V8 XJ Series/XK

211-06

TECHNICAL BULLETIN

Steering Rack Knocking Or Rattling – Revised Lower Steering Column/Rack Return Line – Repair Procedure

ILLUSTRATION 1

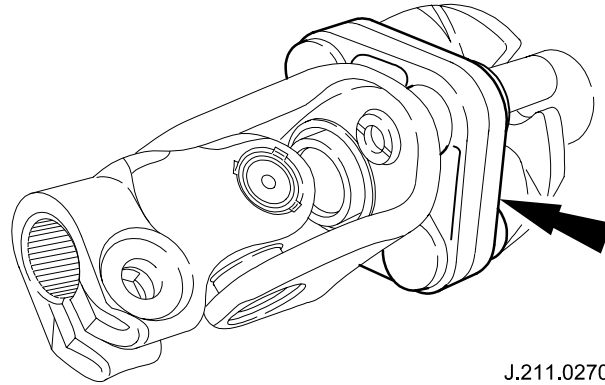
Note: The modified lower steering column has a rubber coupling (Illustration 1). If the modified lower column is present, **continue with PAS line installation only.**

On vehicles prior to VIN A11051 (XK Series) and VIN F20645 (V8 XJ Series), check to see if a modified lower steering column (modified lower steering column has a rubber coupling) has been retrofitted, if not, install a modified lower steering column and new steering rack return line.

On vehicles after VIN A11051 (XK Series) and VIN F20645 (V8 XJ Series), or if a modified lower column has been retrofitted, install new steering rack return line only.

POWER STEERING RETURN LINE - XK

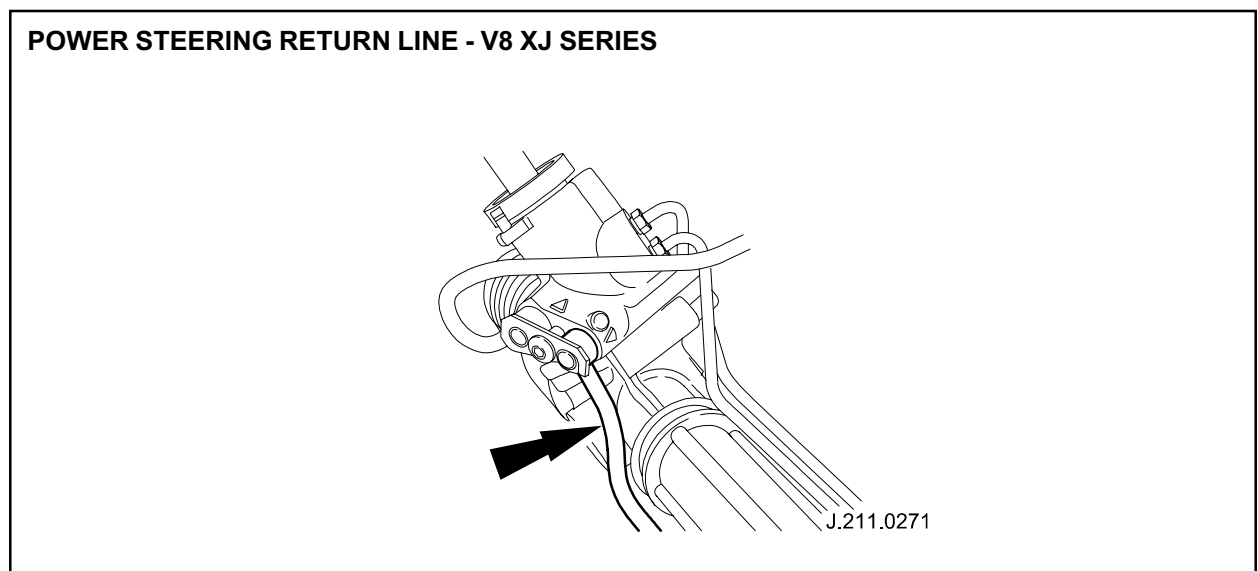
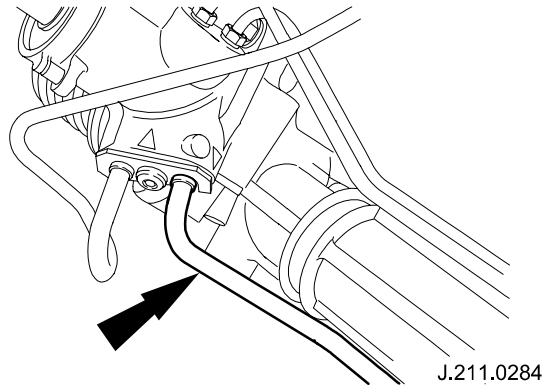
- Install PAS return line (see Workshop Manual, JTIS CD-ROM, section: 211-02, (SRO 57.15.30 for 1997-2000 MY vehicles).
